Item ID: D407-667-105TRN

Item Name: Crosstube Turning Detail

DART AEROSPACE LTD	Work Order:	97873
Description: Crosstube Assembly	Part Number:	D407-667-145
Inspection Dwg: D407-667-145 Rev: C		Page 1 of 2

DRAWING NO. D407-667-145	TITLE CROSSTUBE ASS'Y (407 HIGH FWD)	REV. C	DART AEROSPACE LTD ENGINEERING ORDER		D.E.O. NO. D407-667-145-C-1	SHEET NO. SHEET 1 OF 1	SCALE NTS
DRAWN 9	CHECKED 155	MFG. APPR. 122	APPROVED WD		DE APPR. H		
DATE 11.07.15	DATE 11.07.22	DATE 11.07.22	DATE 11/07/22		DATE 11.07.21

TURNING DETAIL

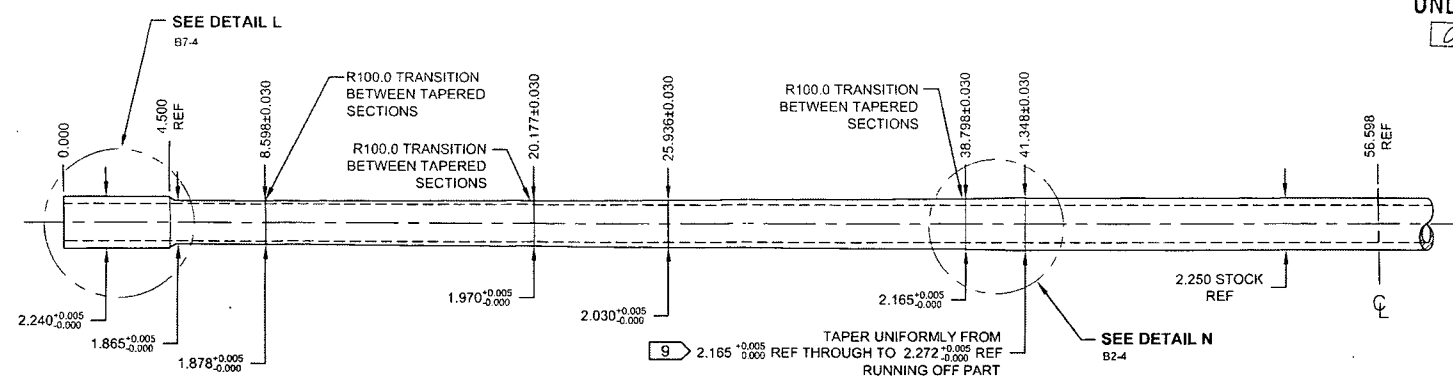
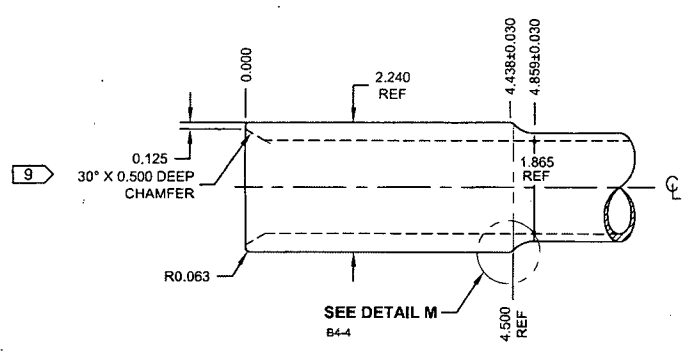
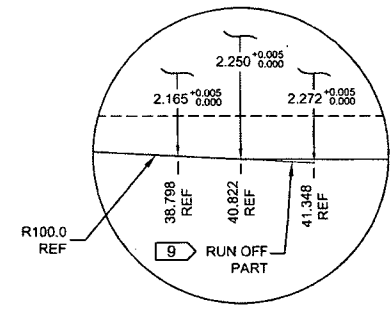
Root Cause	Date	Step	Qty	Description of work order update or Non-conformance	Initial Chief Eng	Action Description	Sign & Date	Verification	QC Inspector
Doc/Data <input type="checkbox"/>	13/5/16	100	1	1 Cuff has a ridge at the top of the radius from machining	CP 13/5/16	Ensure ridge is ground as smooth as possible. Not critical stress area. Acceptable	CP 13/5/16	JTW 13-5-16	 B/15/16
Equip/Tooling <input type="checkbox"/>									
Operator <input checked="" type="checkbox"/>									
Material <input type="checkbox"/>									
Setup <input type="checkbox"/>									
Other <input type="checkbox"/>									
Process <input type="checkbox"/>									
Supplier <input type="checkbox"/>									
Training <input type="checkbox"/>									
Unapproved <input type="checkbox"/>

GRIND ONLY TRANSITION LINES SMOOTH LONGITUDE WAY.

DETAIL P
BONDING STRAP INSTALLATION 2 PL

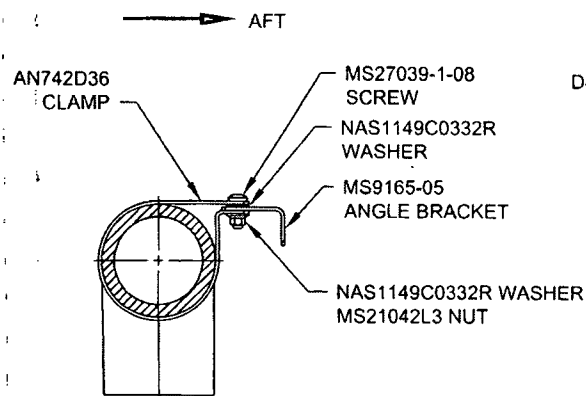
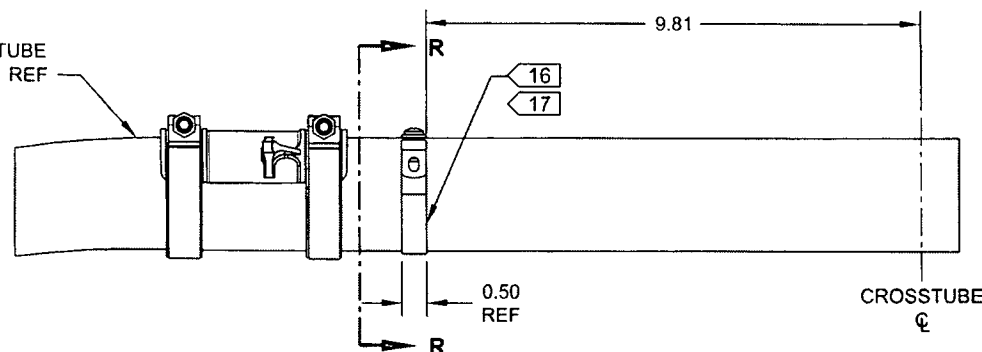
ADD ELECTRICAL GROUNDING STRAP

- 16) MASK AREA UNDER CLAMP PRIOR TO PAINTING
- 17) SEAL EDGES WHERE AN742D36 CLAMP MEETS WITH THE CROSSTUBE USING SIKAFLEX-241/-291 OR MIL-S-8802 CLASS B2 OR PROSEAL 890 SEALANT
- 18) PERFORM RESISTANCE CHECK TO ENSURE MAX RESISTANCE IS 10 MILLIOHMS
